Town of Surfside

Abbott Avenue Stormwater Improvements Project

Addendum No. 6

Date Issued: April 11, 2023

SHEET NUMBER CP-404
PROJECT NUMBER 11494.01

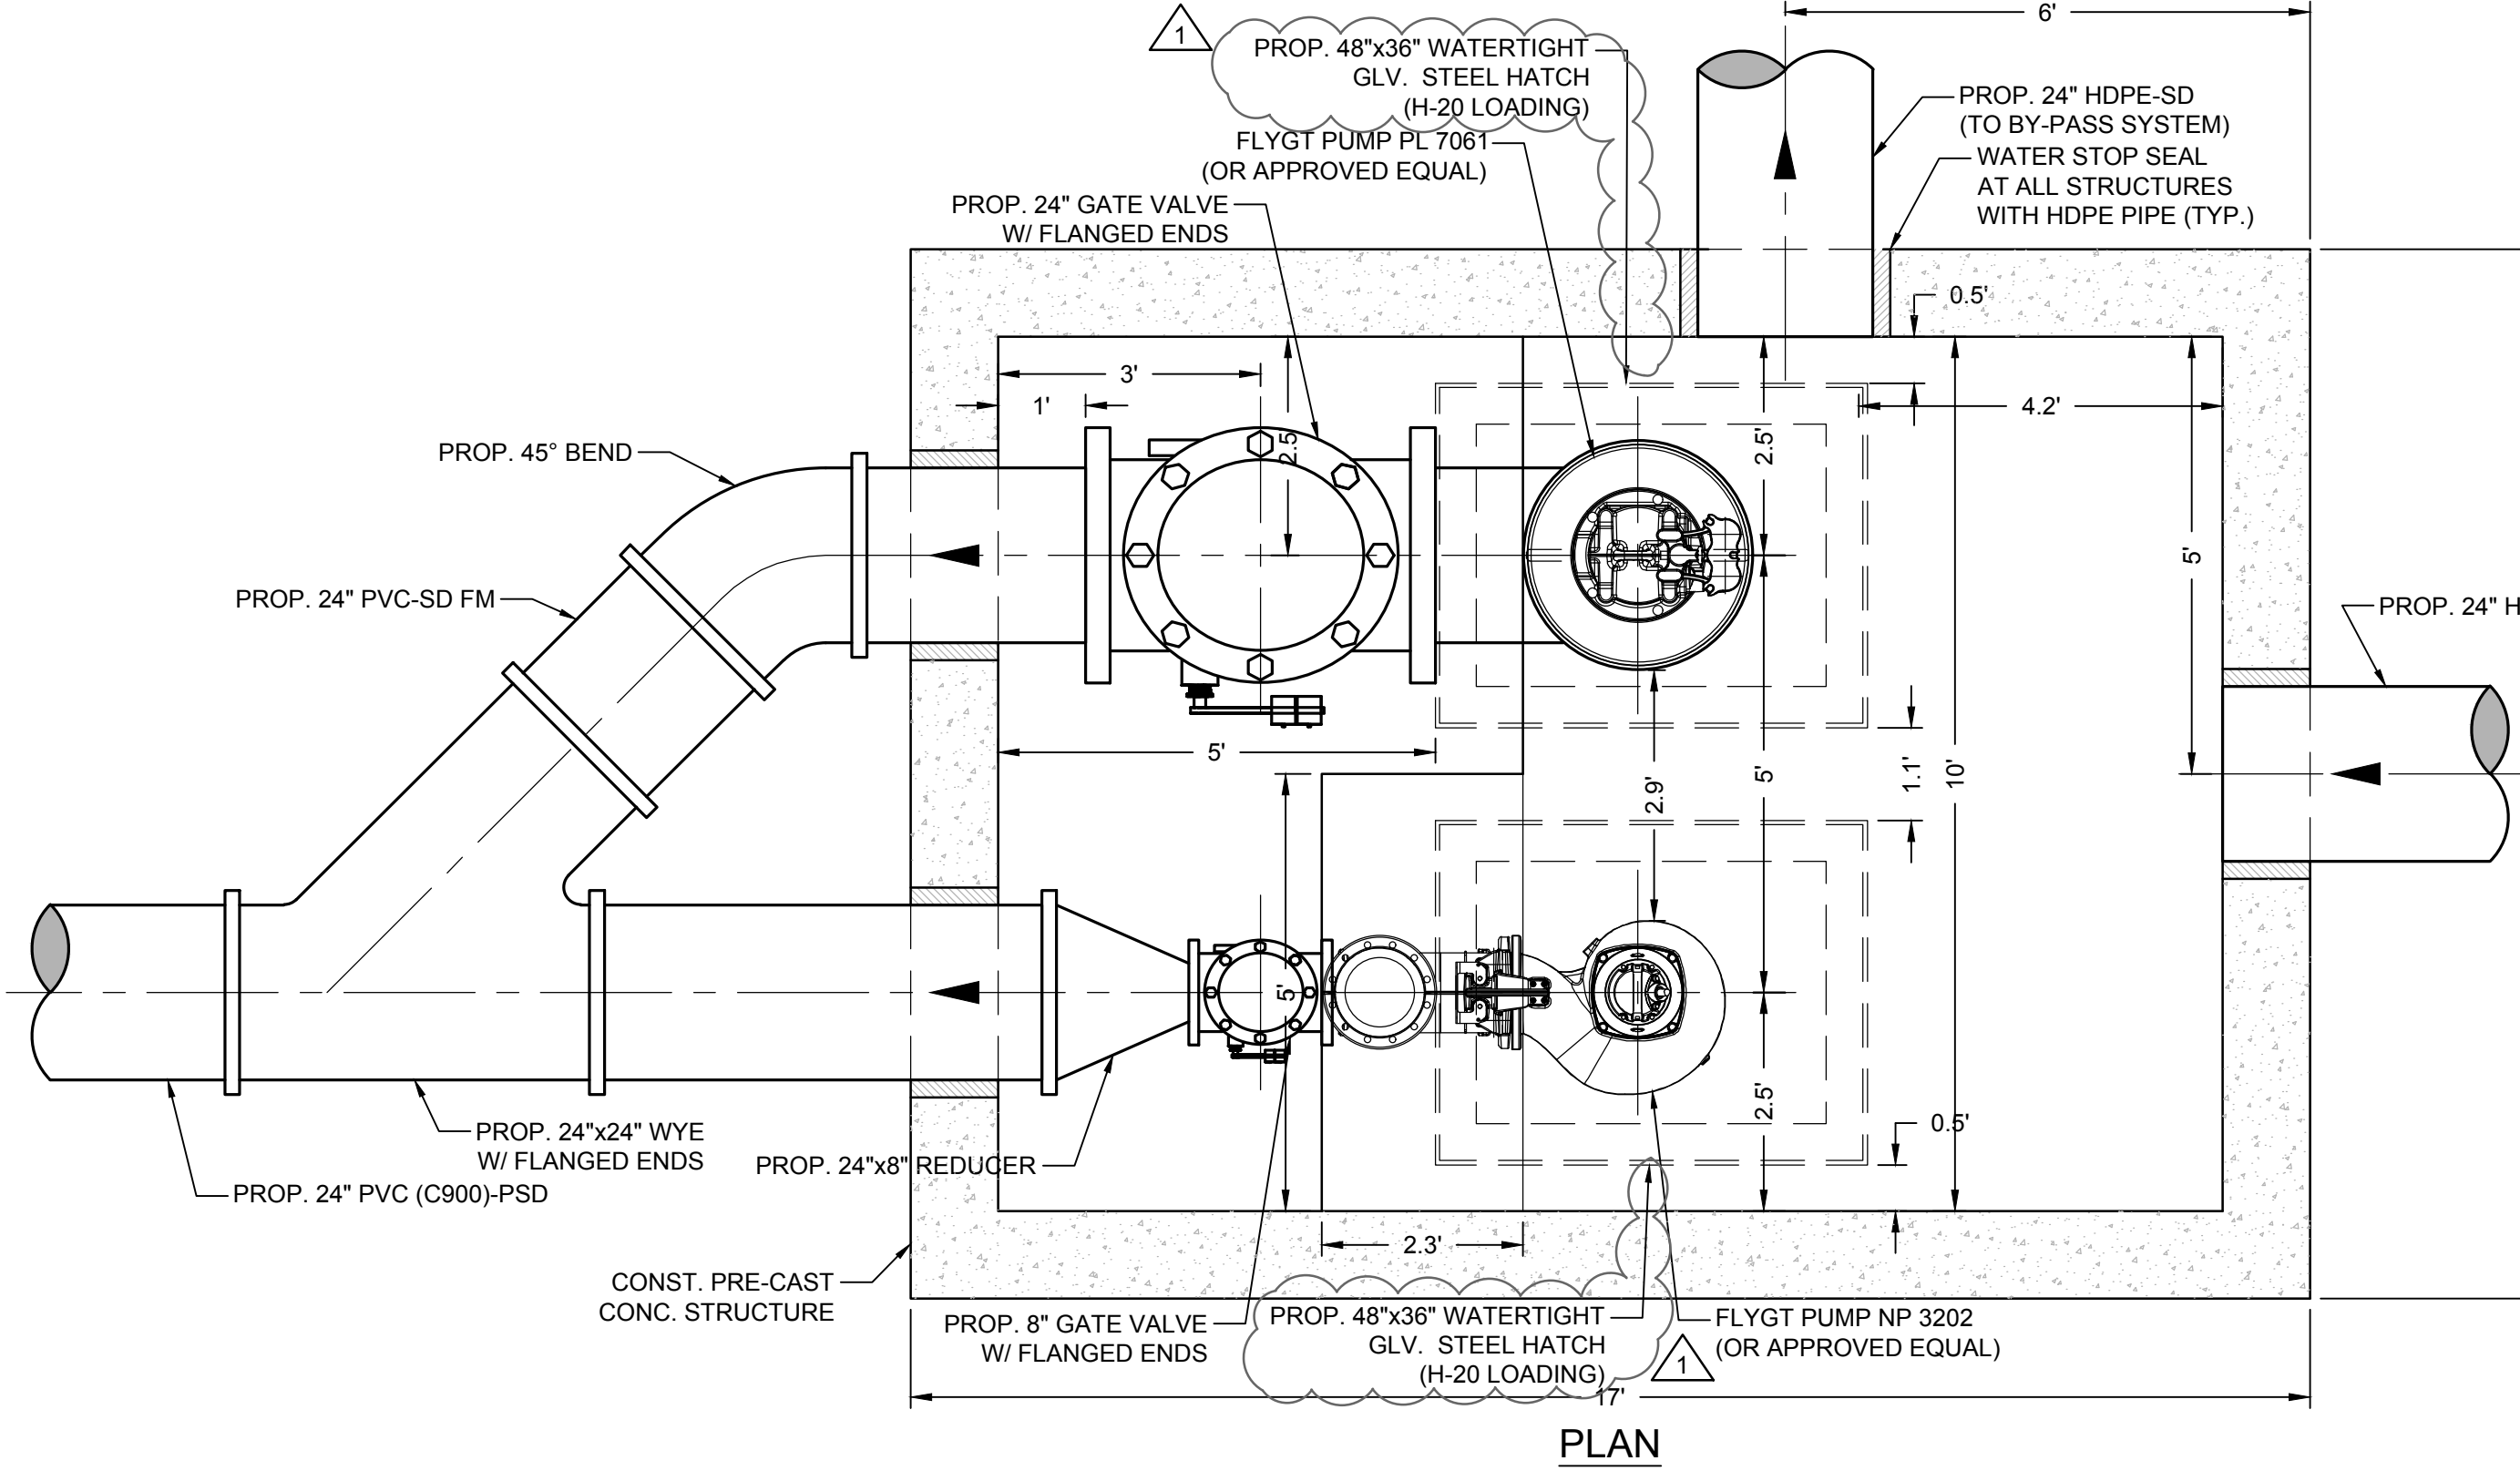
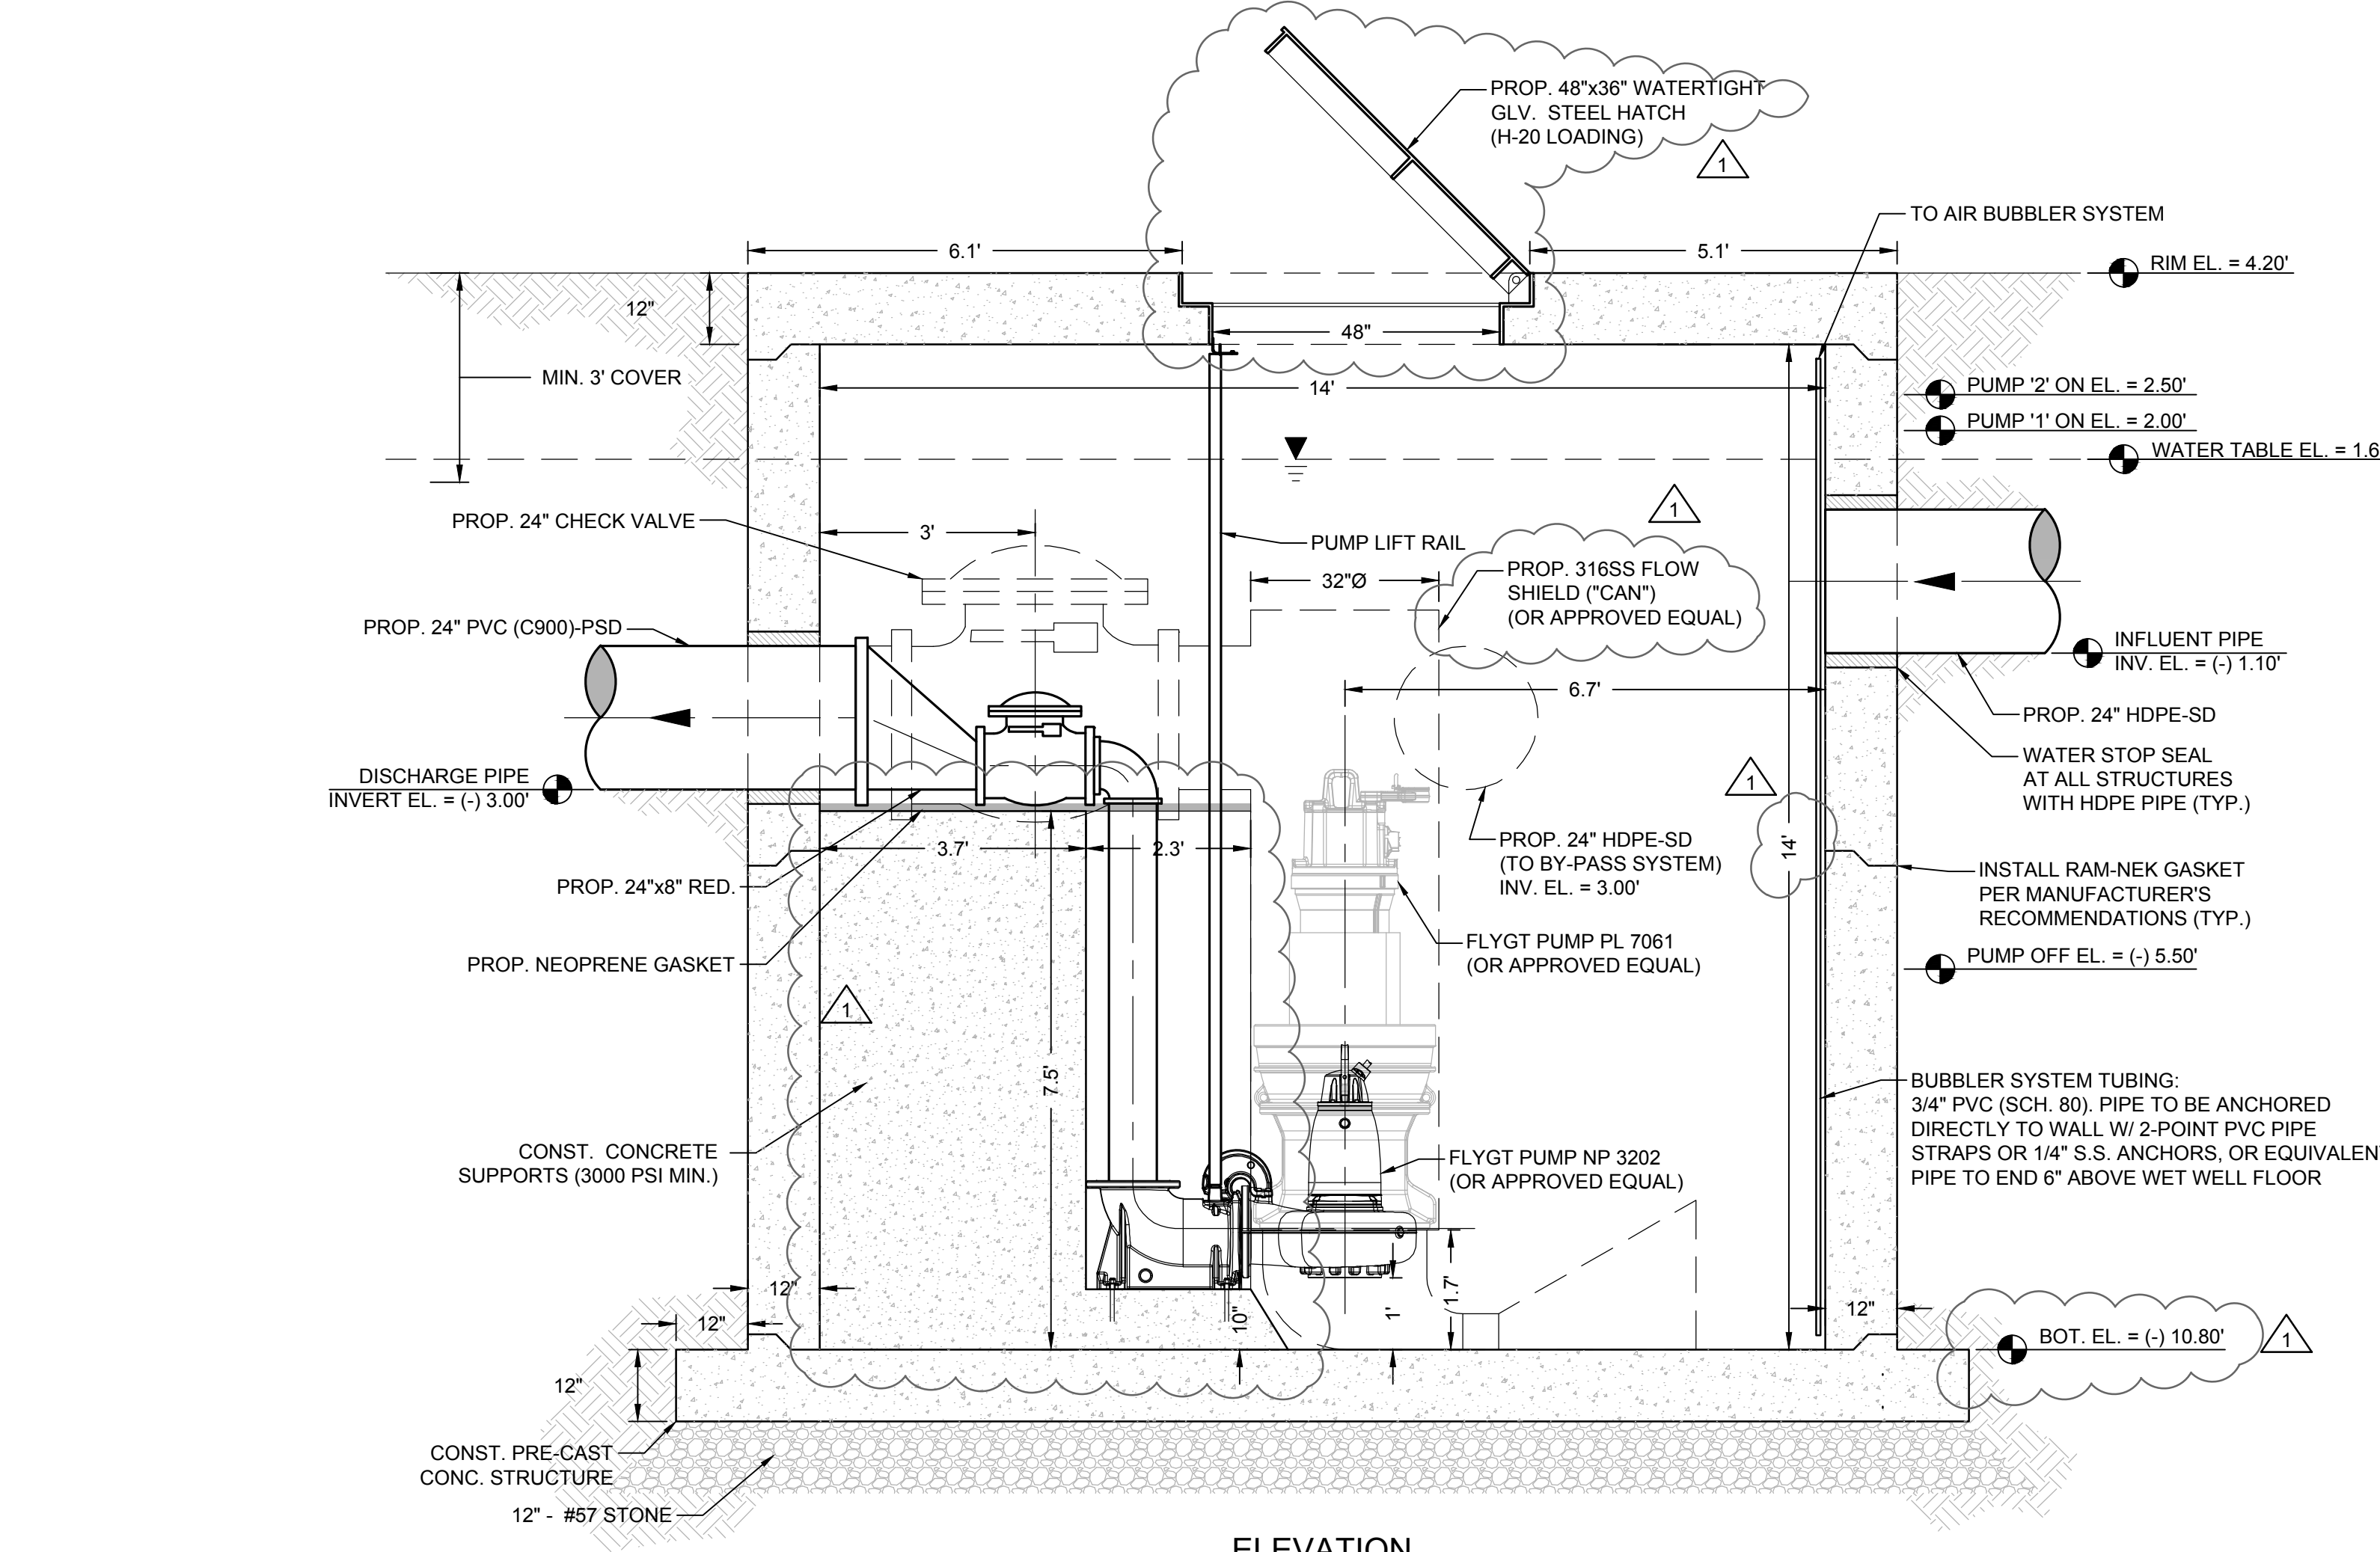
- 7. The pump station Secondary pump would be supplied in a "Pump Can", there's no mention of what material? Being storm water, I would like to assume 316SS to keep the can structure from rotting. The pump details listed on sheet CP-408 do not show the pump can that the pump operates in. I have also attached sheet CP-404 in which I circled the part I am talking about the "Can". Lastly, I have attached a recent submittal sample only can drawing. This is a pretty important piece for longevity of the equipment.**

- 8. Update to Response Relating to Previously Answered Question: Regarding the sets of plans received, we went over them and found the design plans for Pump Station #1, yet the project indicates there will be a second pump stations. Could you please advise if these plans are forthcoming?**

Response: As suggested, the "pump can" can be 316 SS (or approved equivalent) to prevent rotting. The pump station profile on Sheet CP-401 and CP-404 has been updated to better fit the proposed pump can. Refer to the latest plan sheets with Delta #1 revision.

Response: ITB Plan Set includes Sheets CP-401 and CP-404, which include the plan and profiles for both pump stations. Please note sheets CP-401 and CP-404 have been updated and are hereto attached.
